**August 10, 2021
7:00 PM
Planning Board Agenda**

City of Beacon Planning Board Agenda
08/10/2021

Public hearing on application for Special Use Permit and Site Plan Approval, accessory apartment, 1 Wilson Street, submitted by Jon Moss

1
C150
EROSION AND SEDIMENT CONTROL PLAN
SCALE: 1"=30'

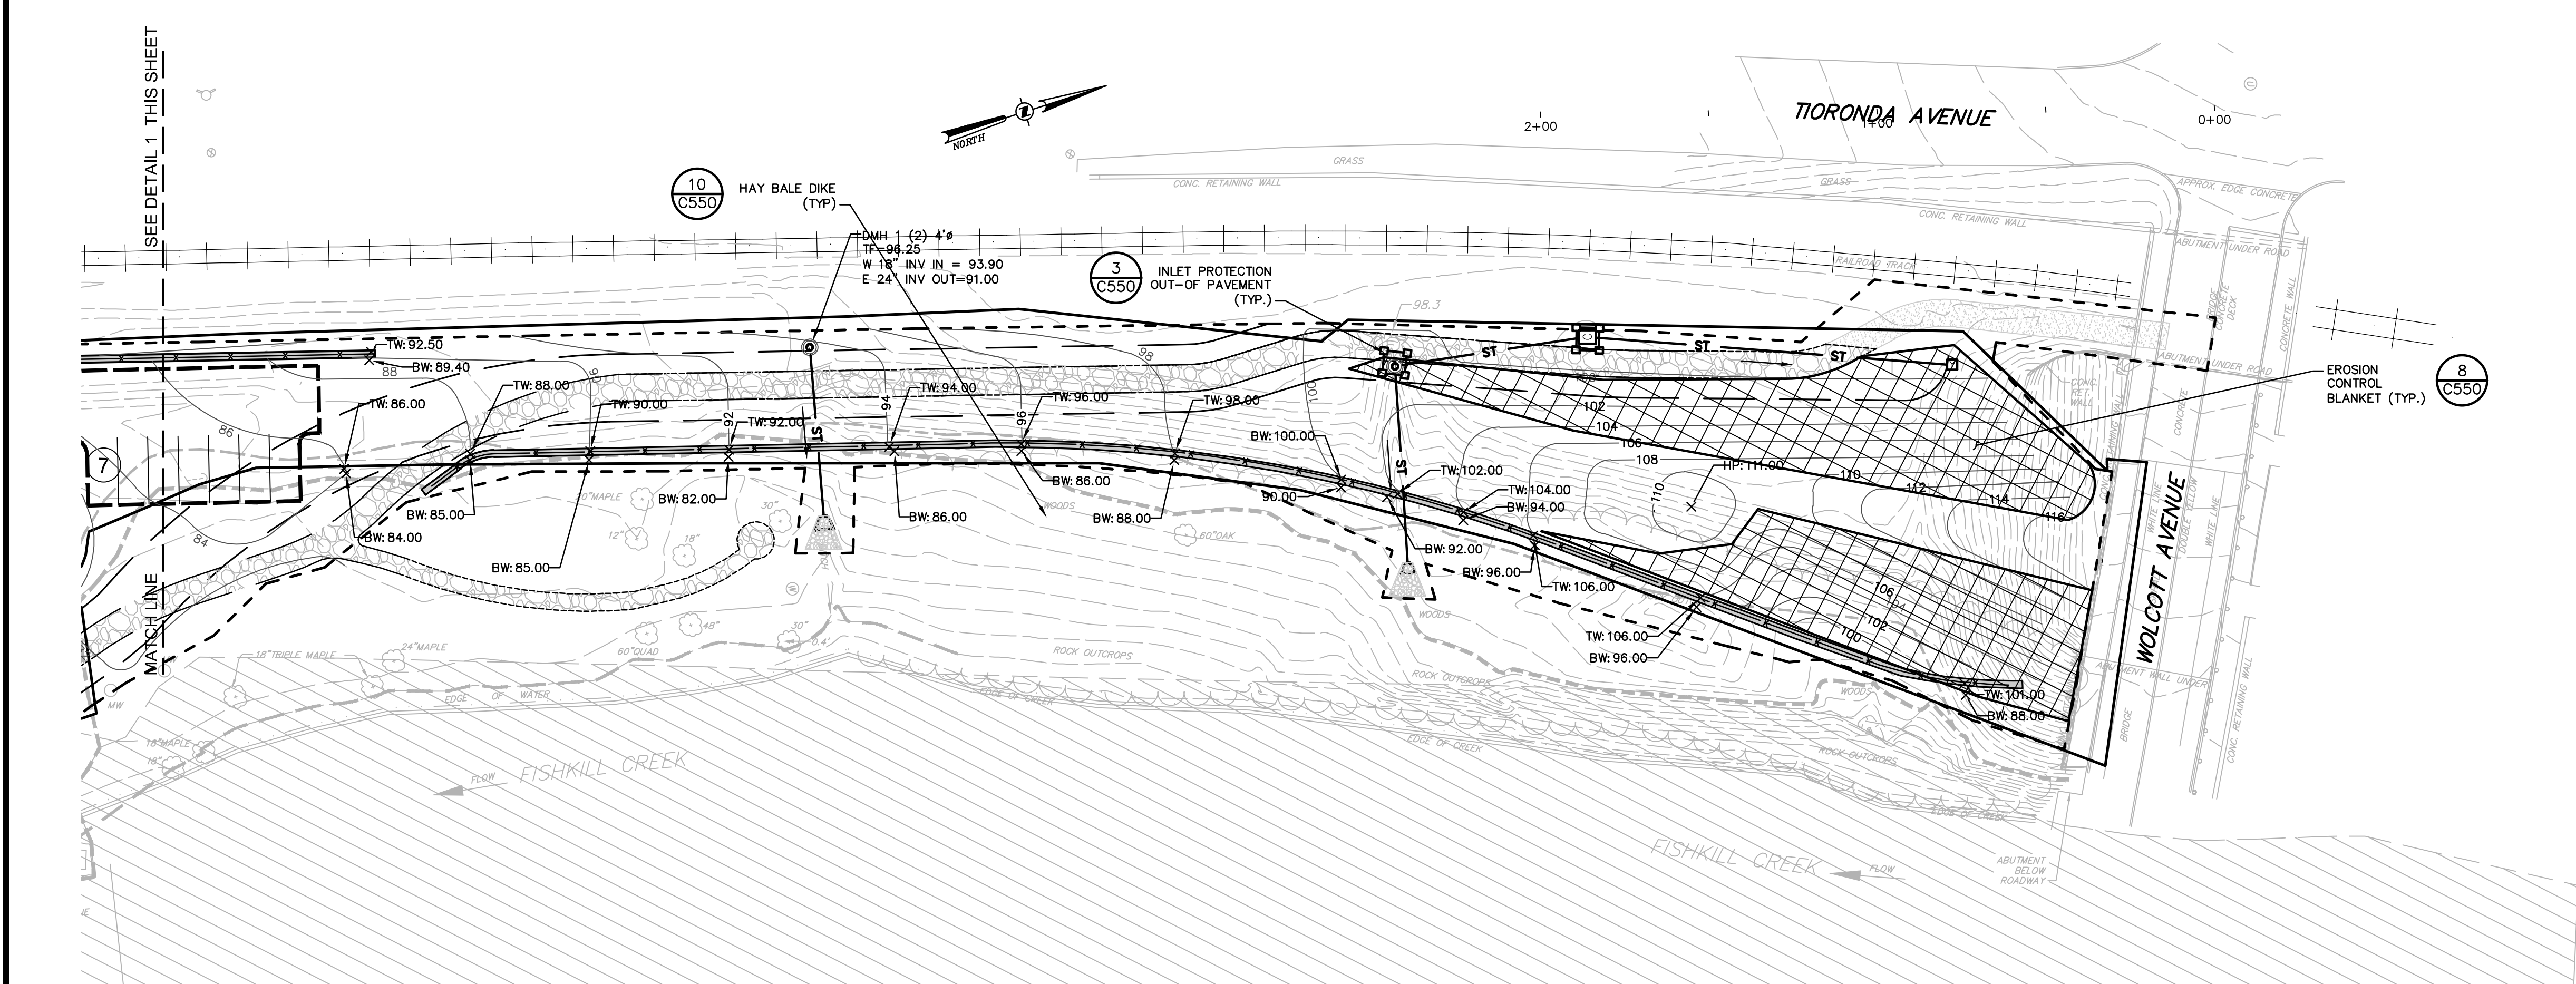
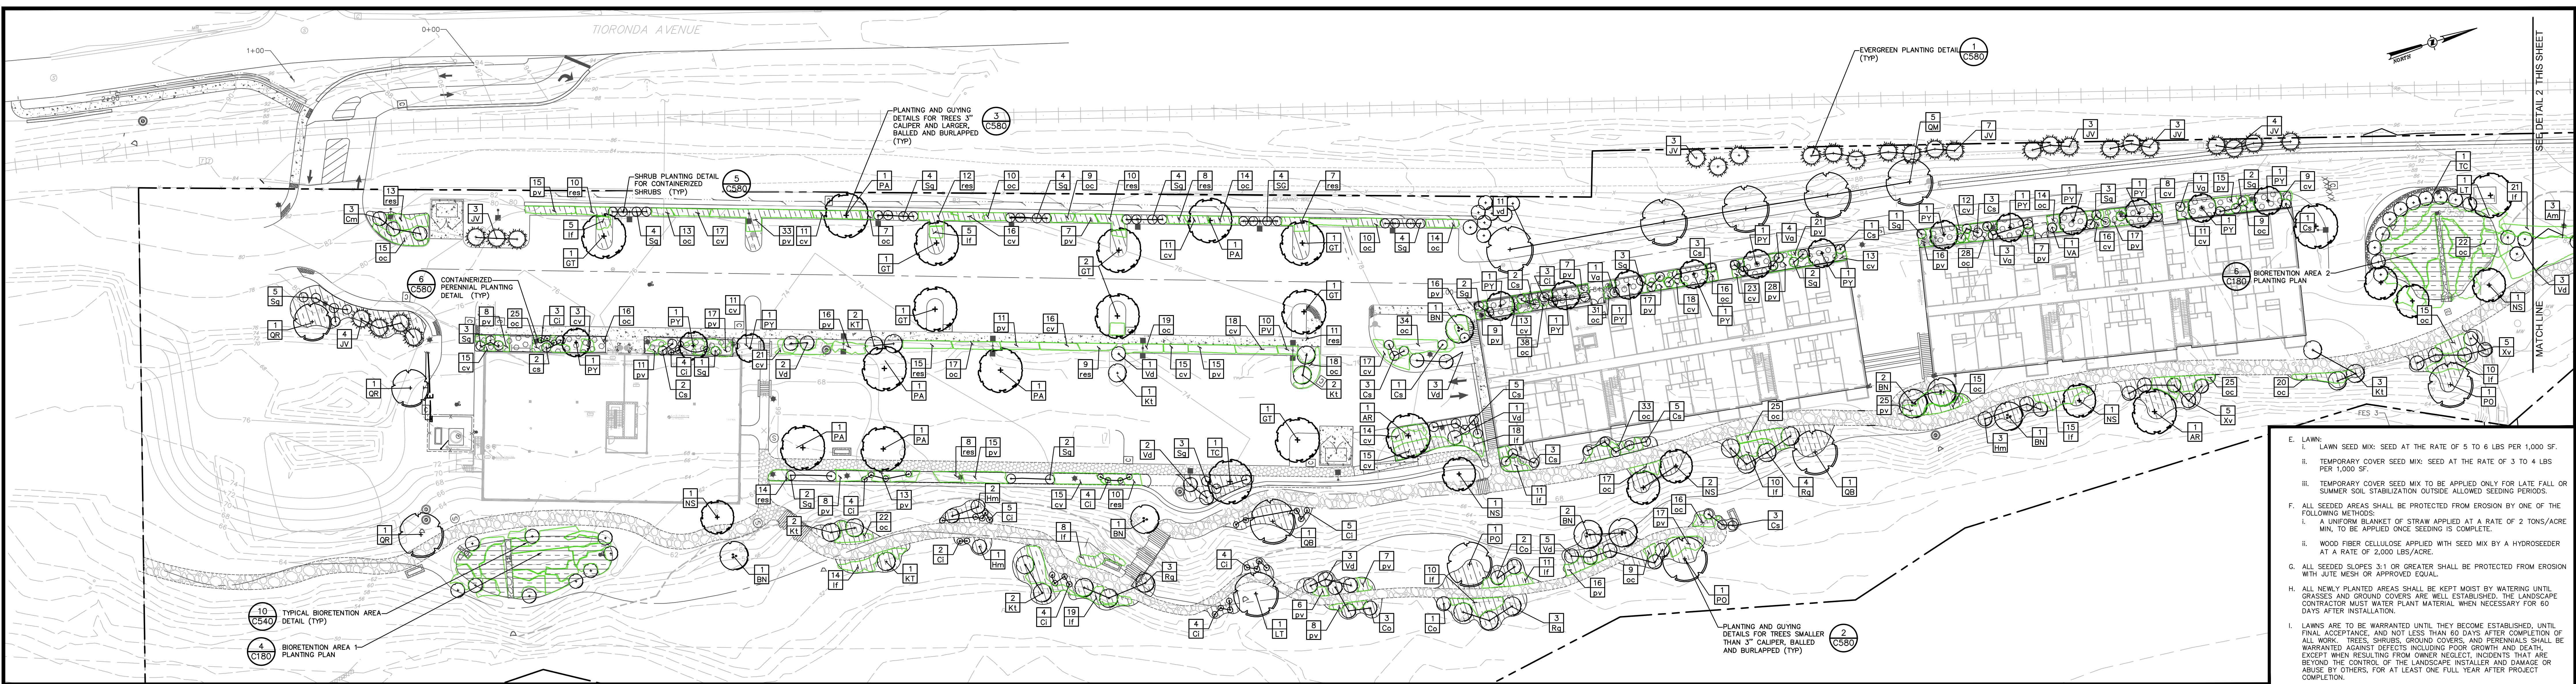
7. On Erosion and Sediment Control Plan Sheet C150:

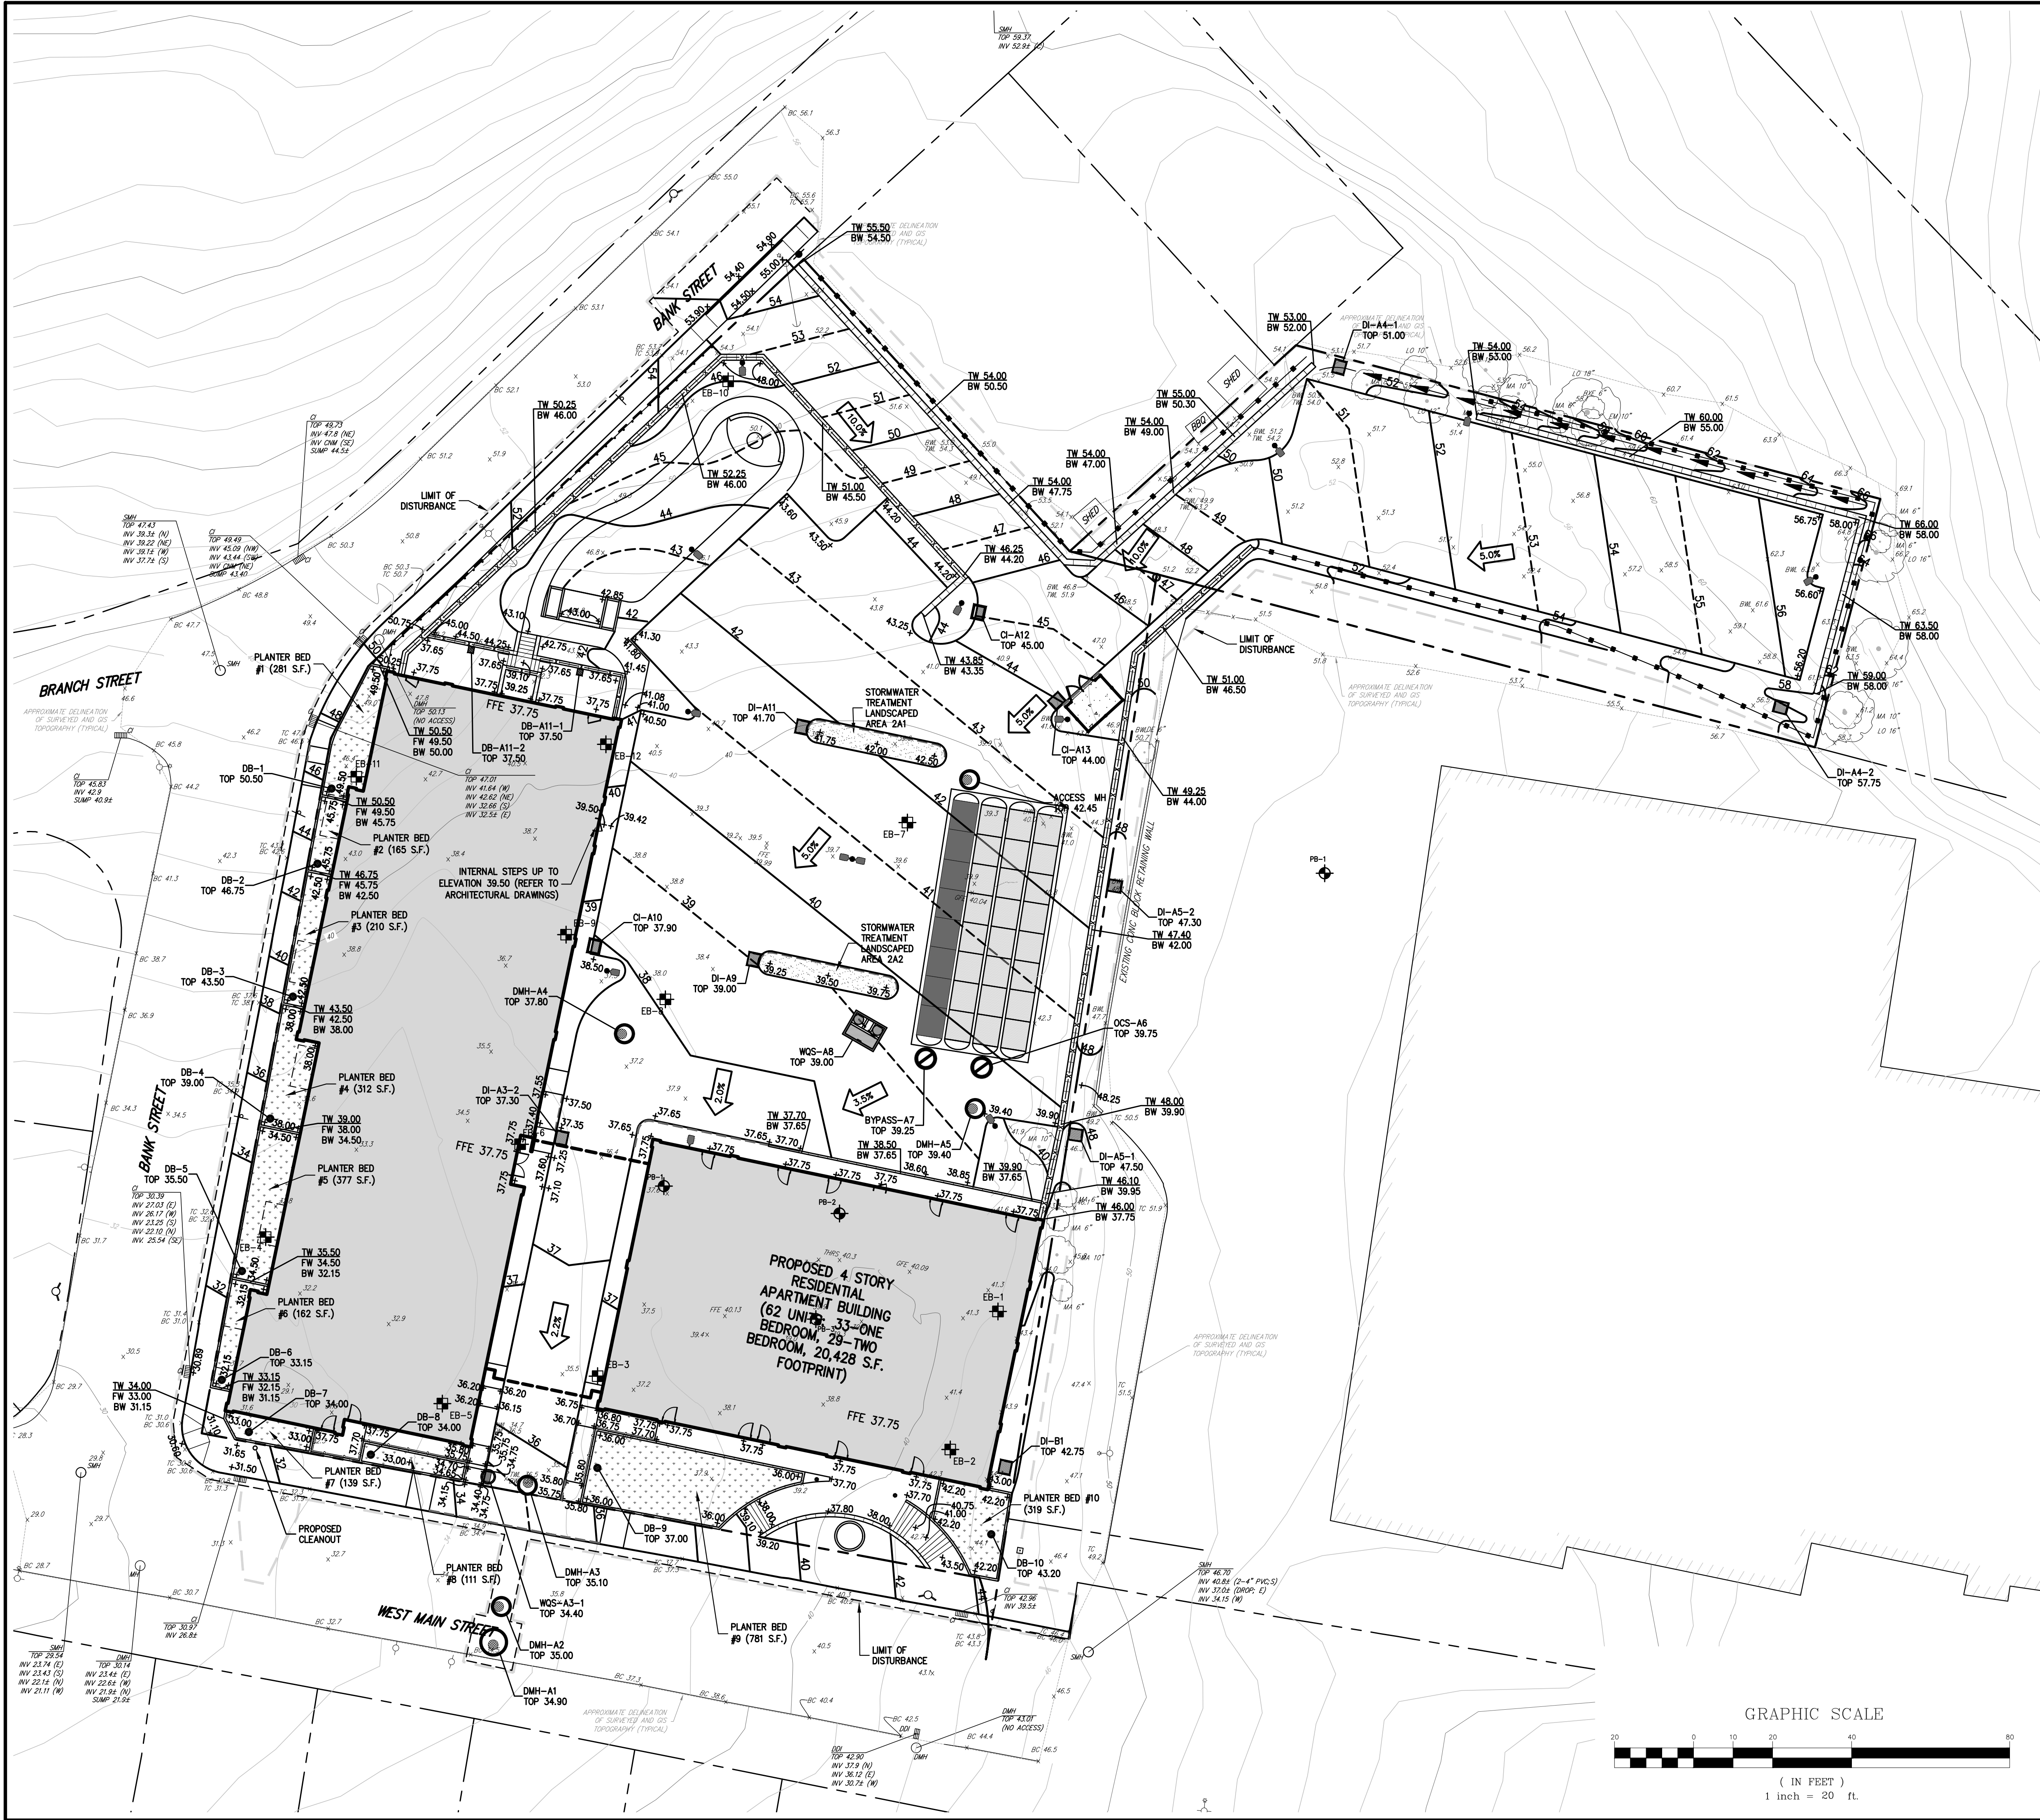
The plan notes in several locations that the proposed retaining walls and fencing atop of these walls is to be designed by others. Construction details should be added to the plan at this time to show the specific type of retaining wall to be used, along with the proposed safety fence atop of the wall. Although construction easements are called out on Sheet 6 of 26 to allow for the construction of these walls, without knowing the type of wall to be used and the requirements for the construction of that wall, it is unclear as to whether the proposed easements are large enough.

2. The plan notes in several locations that the proposed retaining walls and fencing atop of these walls is to be designed by others. Construction details should be added to the plan at this time to show the specific type of retaining wall to be used, along with the proposed safety fence atop of the wall. Although construction easements are called out on Sheet 6 of 26 to allow for the construction of these walls, without knowing the type of wall to be used and the requirements for the construction of that wall, it is unclear as to whether the proposed easements are large enough. **Applicant notes that the wall design will be based upon the site constraints and available easement areas.** Although the wall design is being prepared by others, the type of wall to be used, should be noted on the plans, along with the wall color and visual facing. This allow for a more comprehensive review as to what is proposed visually for the site. This information could be added to retaining wall detail on Sheet 24 of 26.
